CHICK-FIL-A
BRASELTON HWY 53
124 SERD WAY
BRASELTON, GA 30517

FSR#05927

SHEET
EXHAUST HOOD ELEVATIONS
SHEET NUMBER
M-201

3 HOOD ELEVATION - HOOD#2 - SIDE
NOT TO SCALE

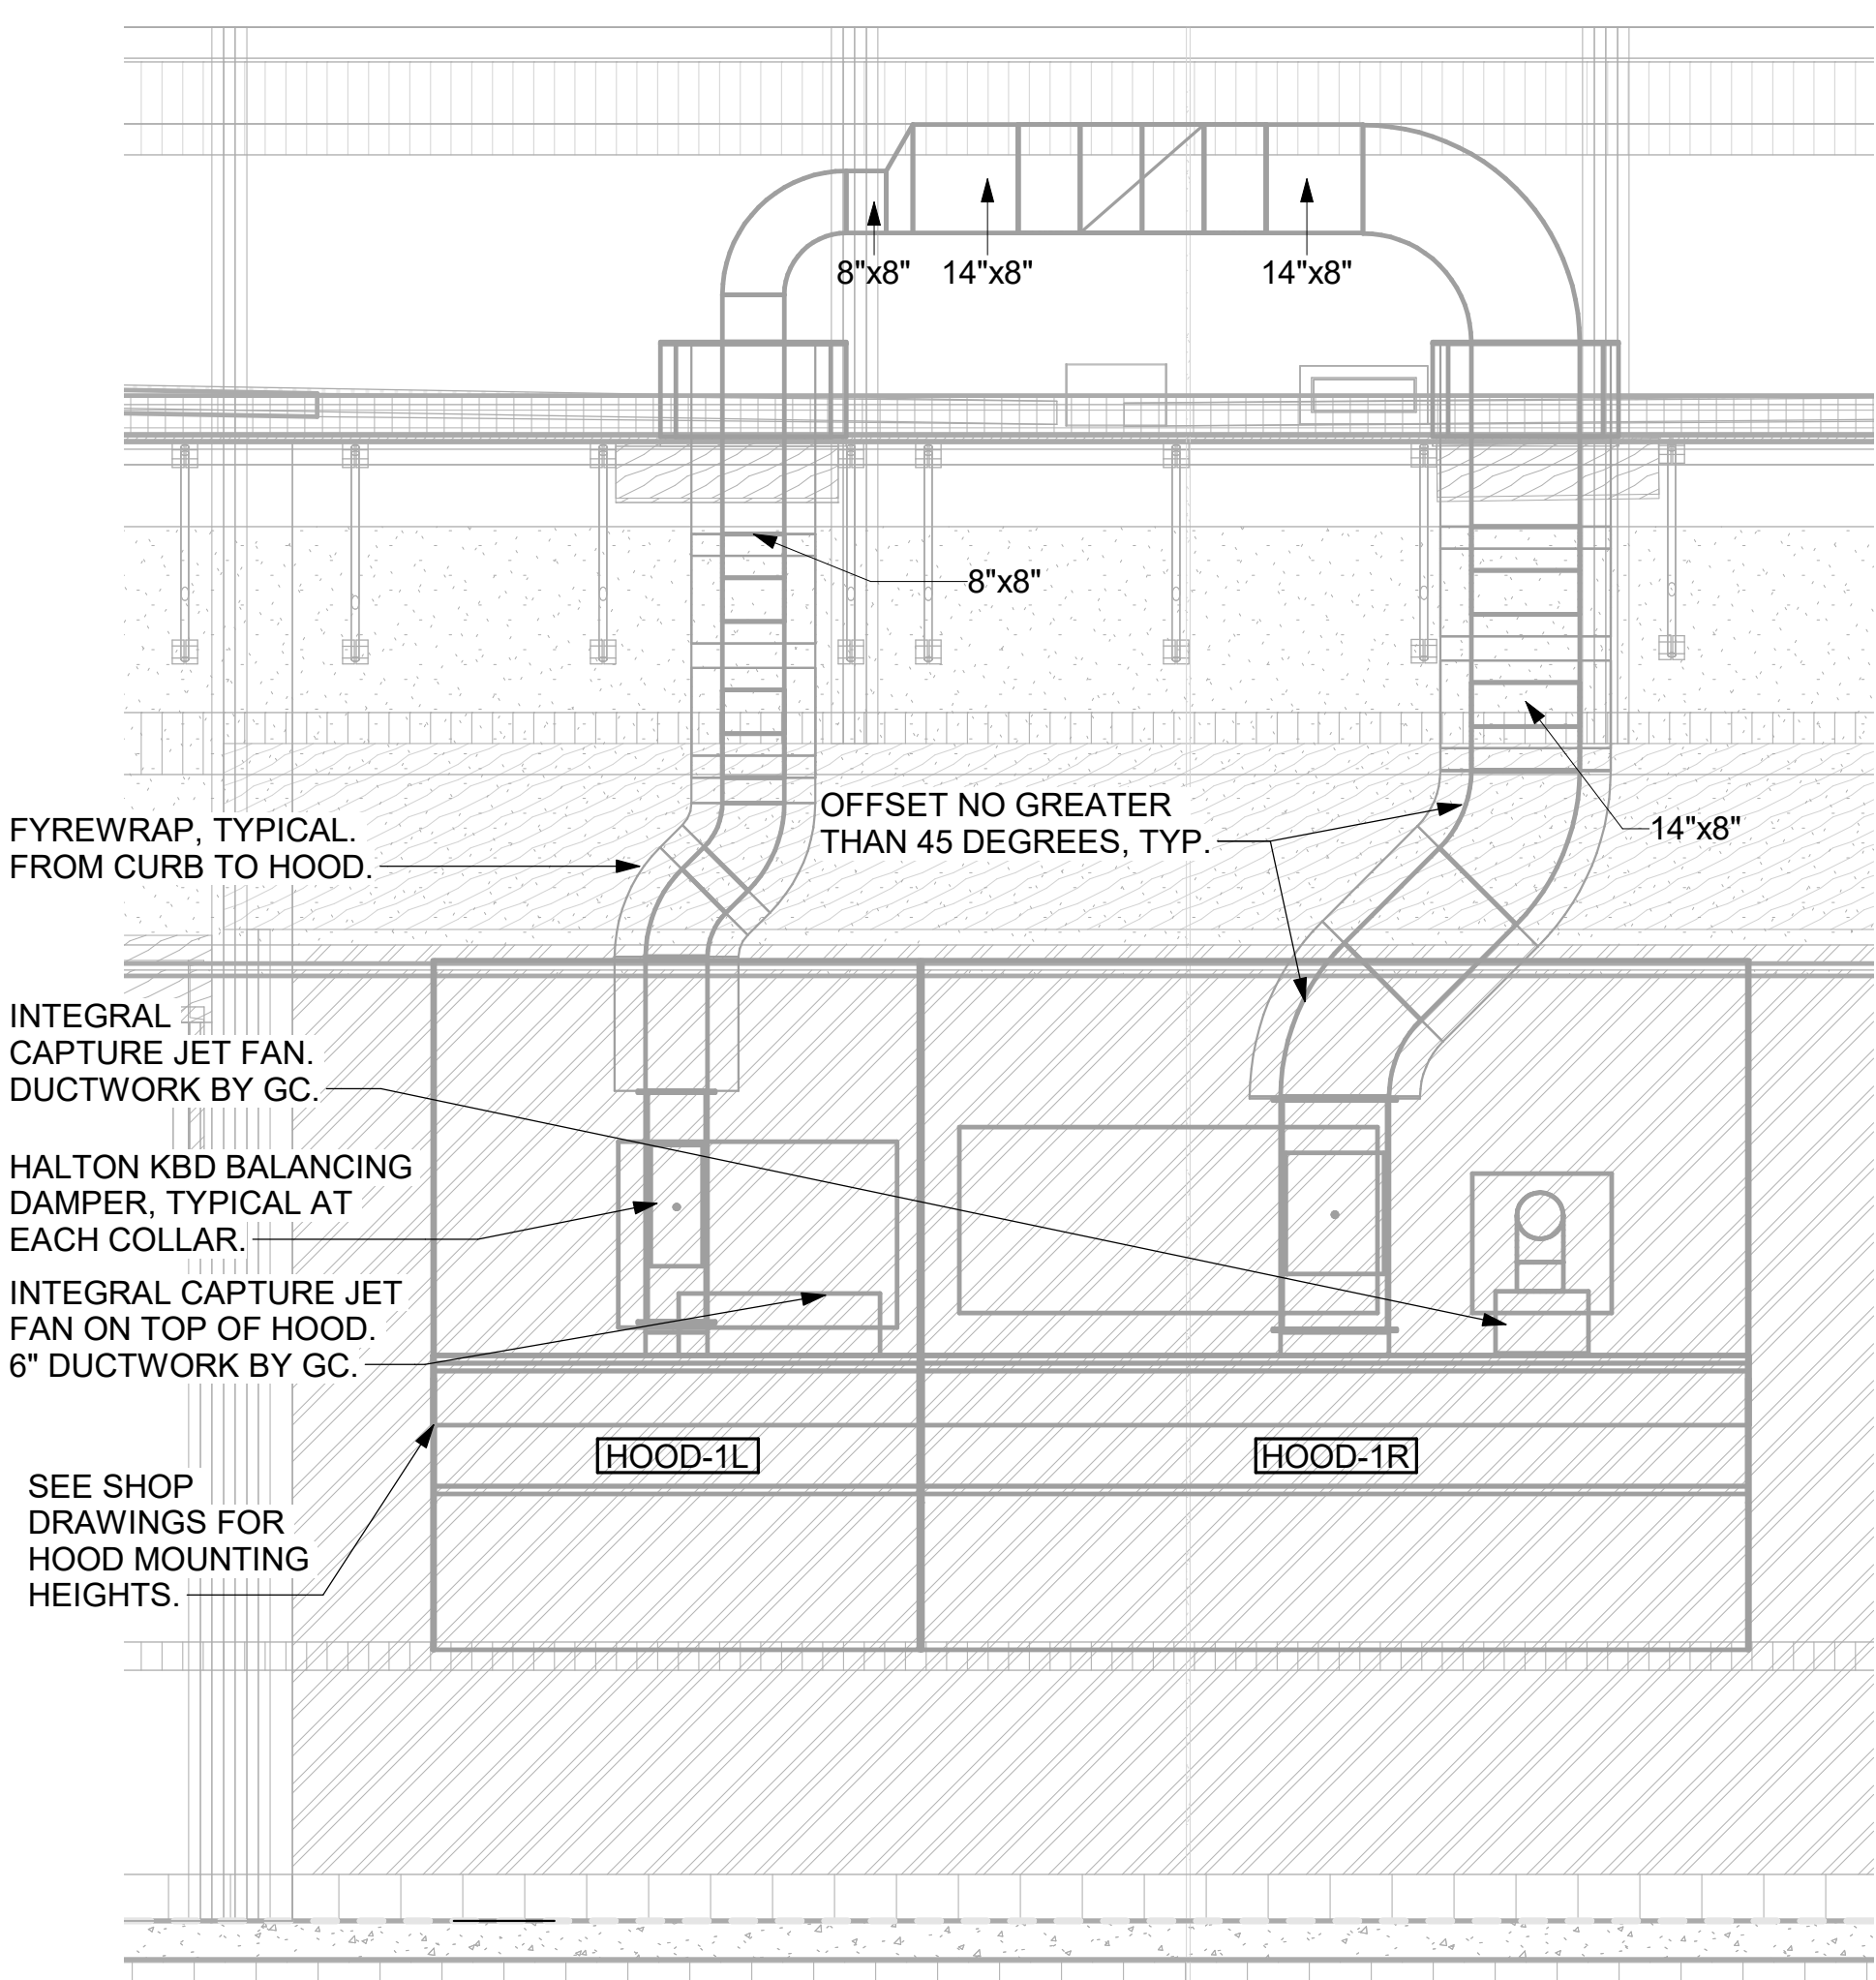
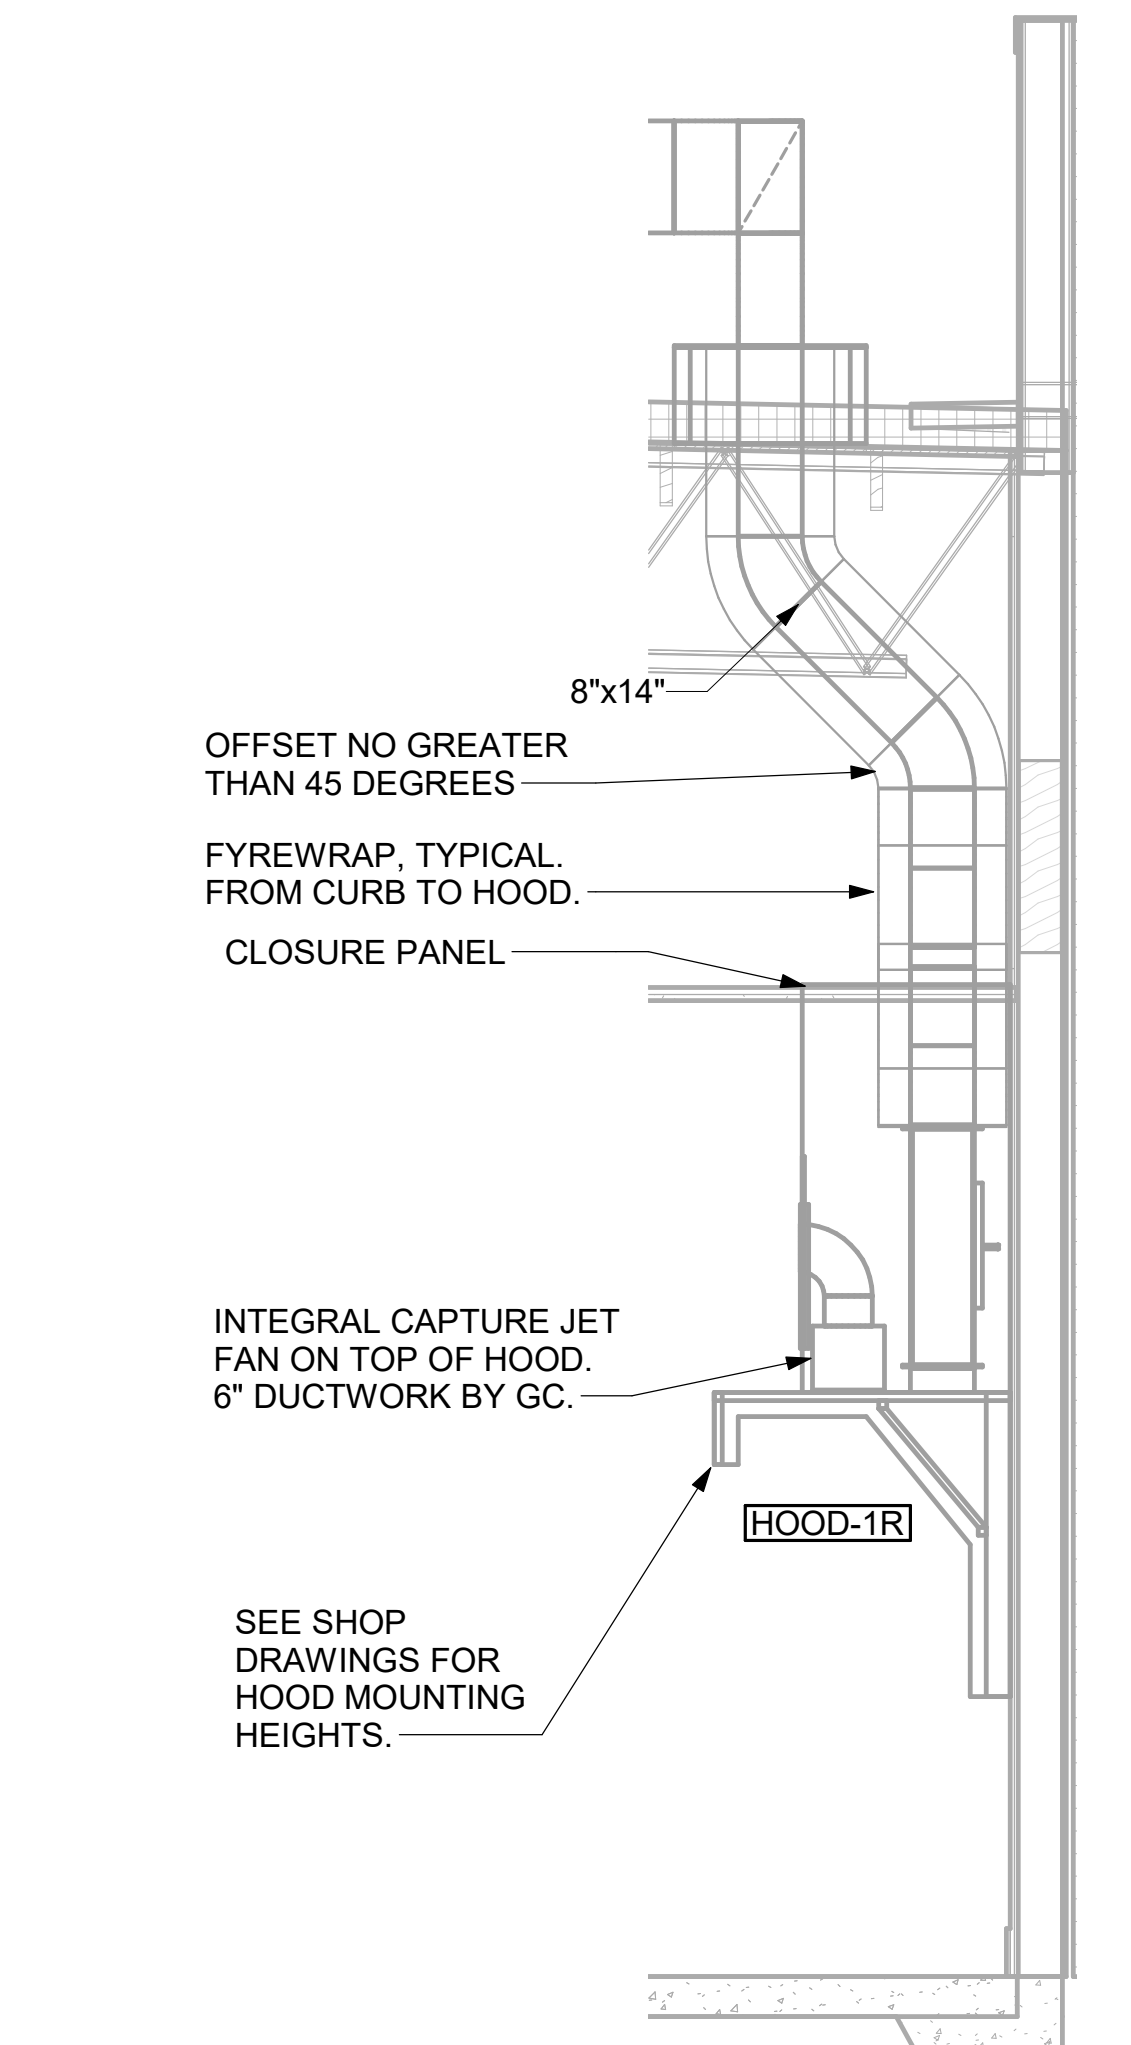
FIRE INSPECTOR COMMENTS:

1. THE KITCHEN SUPPERSSSION SYSTEM WILL REQUIRE A BALLOON TEST TO BE WITNESSED BY THE AHJ.
2. THE KITCHEN HOOD SYSTEM WILL REQUIRE A HOOD LIGHT TEST TO BE WITNESSED BY THE AHJ.
